UNITED STATES PATENT AND TRADEMARK OFFICE

| APPLICATION NO. | FILING DATE | FIRST NAMED INVENTOR | ATTORNEY DOCKET NO. | CONFIRMATION NO. |
|-----------------|-------------|----------------------|---------------------|------------------|
| 09/939,516 | 08/24/2001 | John B. Harvey | 26346-1 | 2442 |

Office Action Summary

DETAILED ACTION

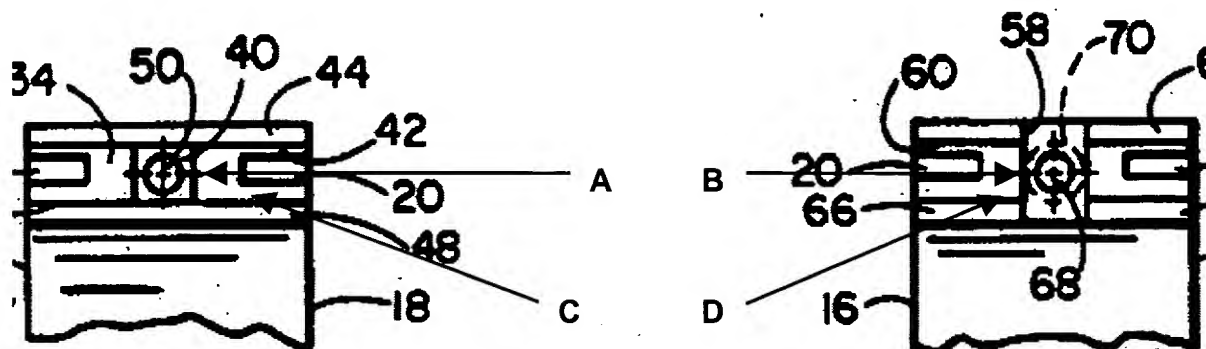
wherein the land has a first pair **A** (Figures 5 and 6 reprinted below with annotations) of planar alignment surfaces;

wherein the recess has a second pair **B** of planar alignment surfaces complimentary to the first pair of planar alignment surfaces wherein contact of the first pair of planar alignment surfaces with the second pair of planar alignment surfaces when the land is received in the recess provides axial alignment of the first semi-circular member with the second semi-circular member;

wherein the land has a third pair **C** of planar alignment surfaces; and

wherein the recess has a fourth pair **D** of planar alignment surfaces complimentary to the third pair of planar alignment surfaces wherein contact of the third pair of planar alignment surfaces with the fourth pair of planar alignment surfaces when the land is received in the recess provides radial alignment of the first semi-circular member with the second semi-circular member (Figures 1-6).
